Tamworth Solar Farm

Response to Request for
Information 29/4/20

Prepared for: Tamworth Solar Farm Pty Ltd
May 2020

This document contains Tamworth Solar Farm's response to a request for additional information from the Department of Planning, Industry and Environment dated 14th April 2020 as well as additional requests on the 4th, 7th and 12th of May.

meters

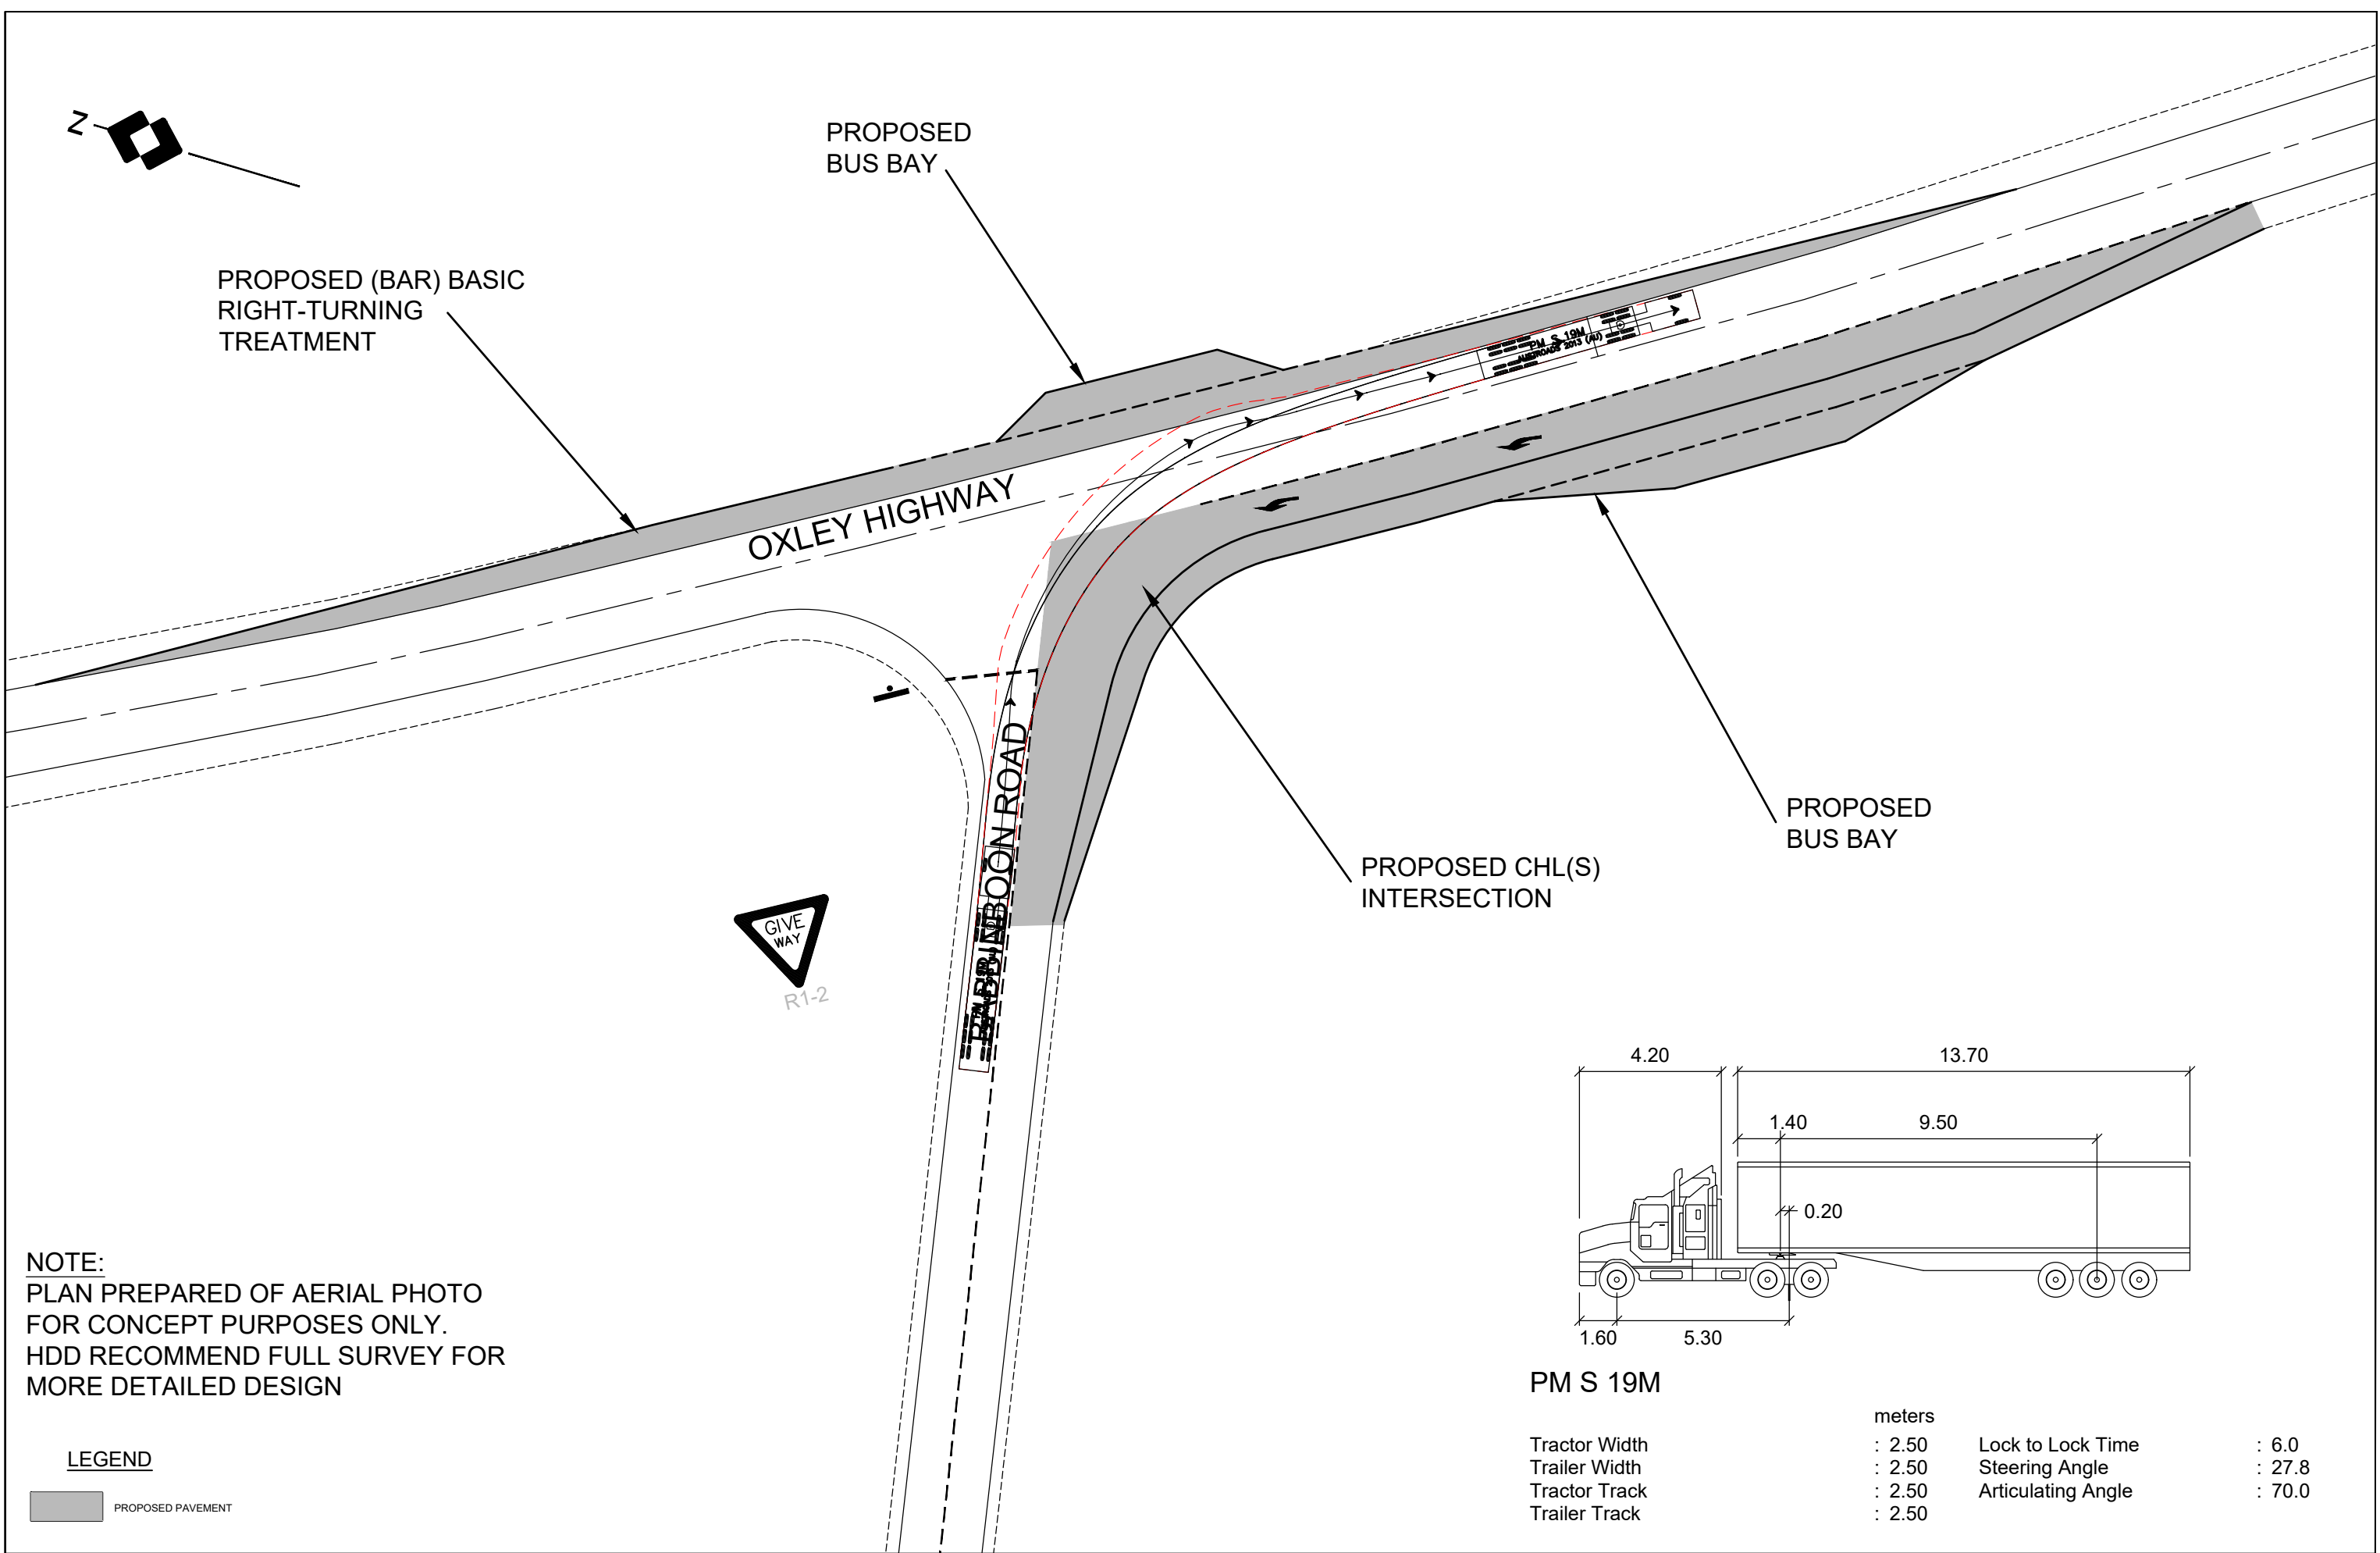
Requested Information: *"Clarify the nature and location(s) of the intersection upgrades and intersection treatment types and include a swept path diagram for the largest vehicles travelling to and from the site."*

The intersection of the Oxley Highway and Babbinboon Road is being upgraded to include a deceleration lane for vehicles turning left into Babbinboon Rd. Based on the discussions with TfNSW and on their request, a Basic Auxiliary Right (BAR) treatment is being provided at the intersection. Furthermore, two new bus stops will be provided that will give a much greater level of safety than the existing bus stops. A concept plan for the upgrade and a swept path diagram for the largest vehicle is included as Appendix A. Further information on why a higher level of treatment is not required is provided in the Technical Design Note in Appendix F along with information on sight lines for the bus stops.

To provide better bus stop locations at the intersections, Tamworth solar farm will construct sealed bus stops as shown in Appendix A. These locations have been discussed with Macphersons Coaches and they think the sites are suitable. An email from Macphersons is provided in Appendix C. The request they made to have the bus stop on the northern side of the highway widened to 3.6m has been included in the concept design in Appendix A.

Figure 1-4: Extension to Open Camp Site 7 for the Tamworth bound lane Basic Auxiliary Right treatment (Study Area 2) (Base image source: Bing Satellite).

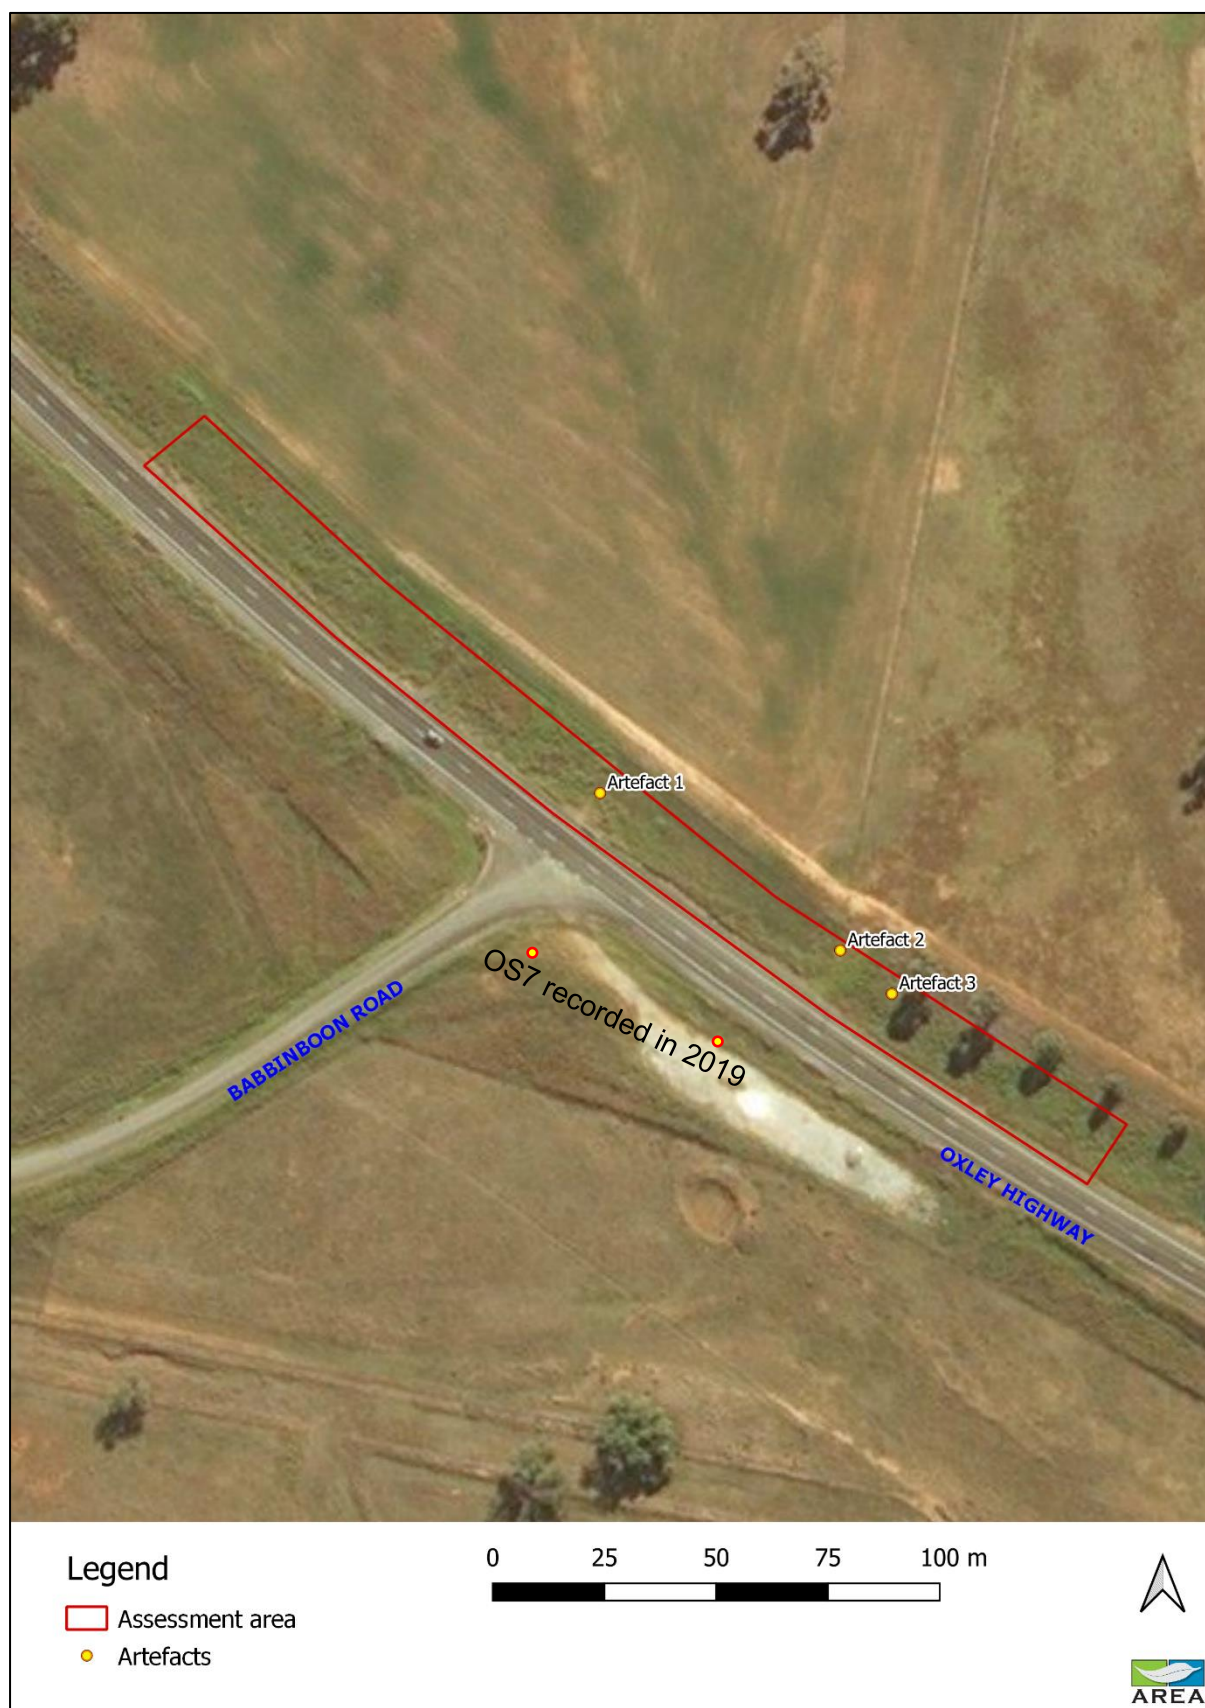
Three Aboriginal objects were recorded on an area not built on fill toward the agricultural fence line (Figure 1-4). One stone artefact has characteristic attributes while two were possible artefacts. Unfortunately, the photos taken of these objects were all out of focus and are not useful for the purpose of this report. The following attributes were noted:

- Object 1 is a basalt broken flake, 42x26x4mm, 20 per cent cortex possessing a bulb, eralier scar, broken narrow platform with evidence of bipolar flaking.
- Object 2 is quartzite and possibly a broken flake 16x9x9mm, no cortex. A possible negative flake scar was noted. This is in proximity to other more definitive Aboriginal objects both sides of the highway.
- Object 3 is quartzite and possibly a broken flake 23x22x6mm, no cortex, a bulb and possible flake scar. This is in proximity to other more definitive Aboriginal objects both sides of the highway.

For the purposes of this report the 'possibles' have been managed as they were bona fide Aboriginal objects.

Figure 1 – Sight line (red line) showing the sight line for a driver exiting Babbins Road is not impacted upon by a bus in the proposed hard stand area

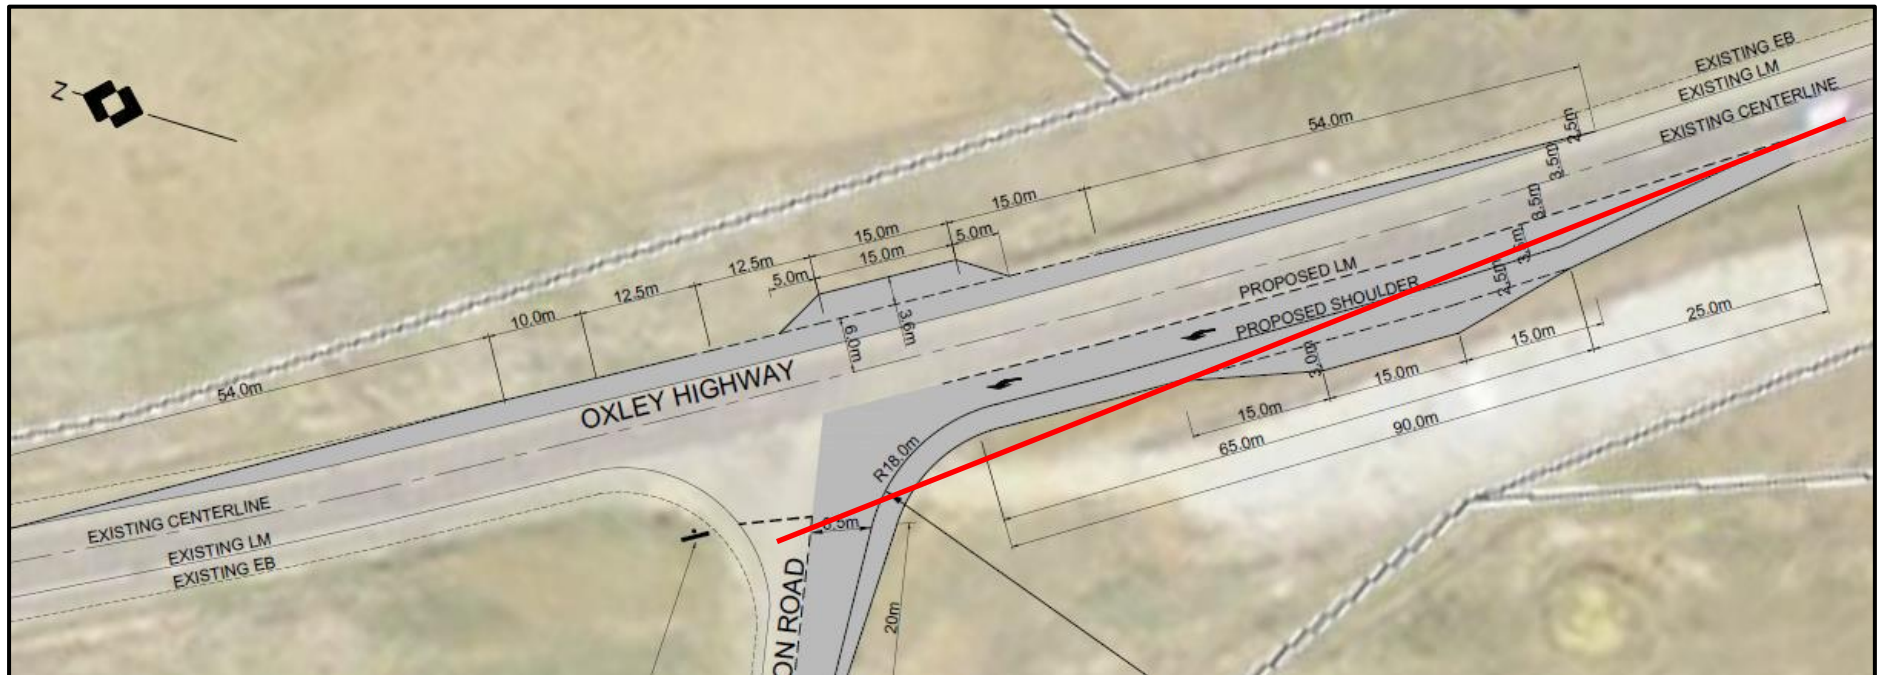
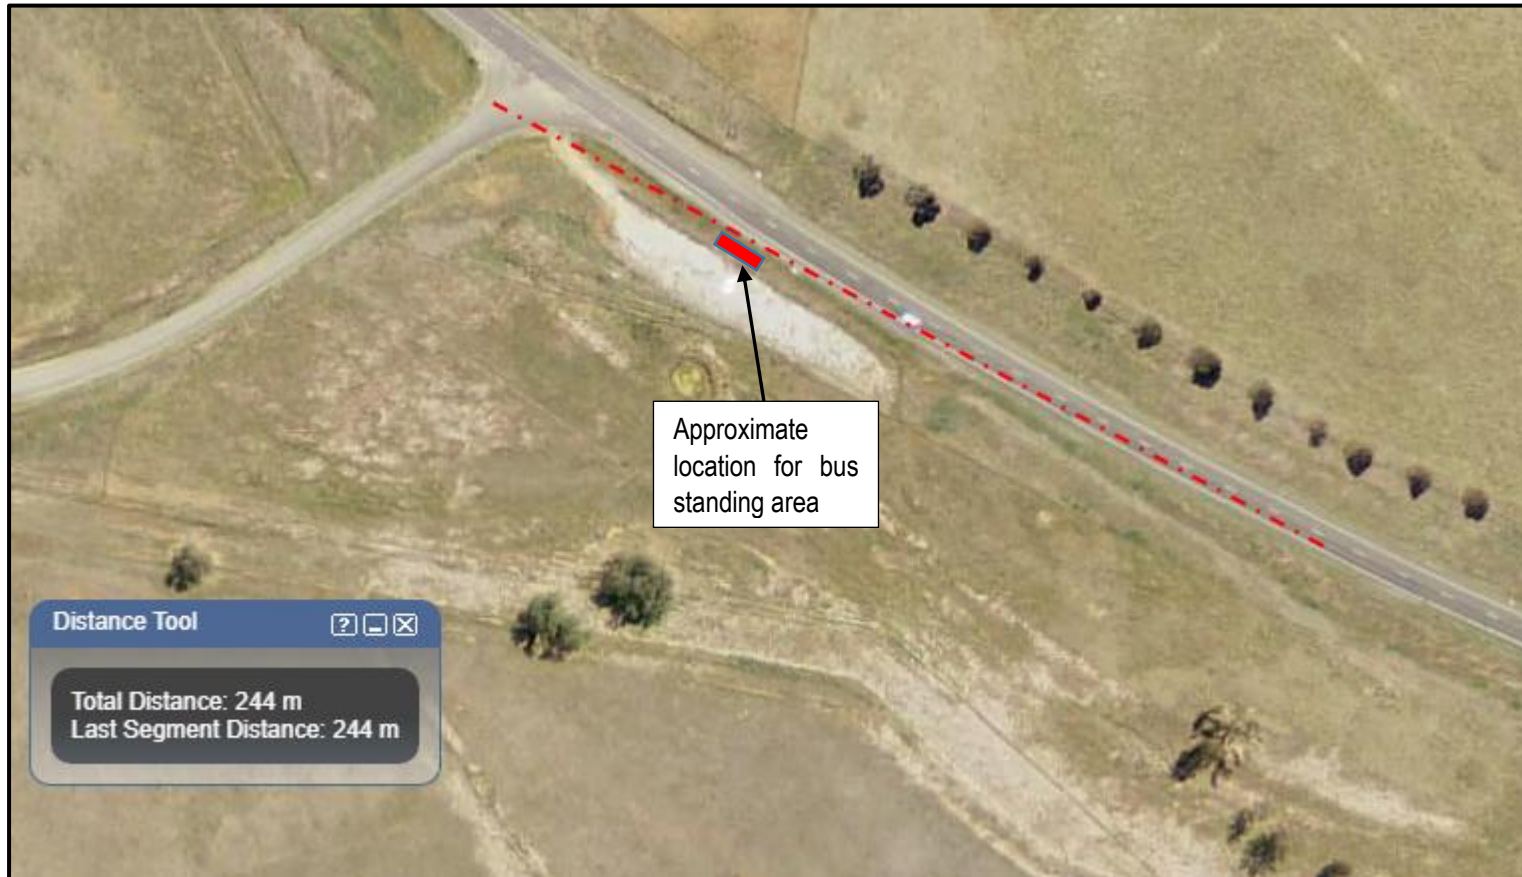
An assessment has been completed for the impact of the proposed bus standing area to the south of the intersection of Babbins Road and the Oxley Highway to ensure that the bus standing area does not impact upon the sight lines for a driver exiting Babbins Road. The Figure 1 and 2 show that the design will not impact upon this sight line, with the curvature of the road providing a benefit for the sight line. The bus standing zone is located behind the 3.5 metres wide deceleration lane and the 2.5 metres wide sealed shoulder and hence 6 metres away from the northbound travel lane on the Oxley Highway. It is noted that the current intersection layout and bus stand area is located adjacent to the running lane northbound on the Oxley Highway and as such could impact upon the sight line.
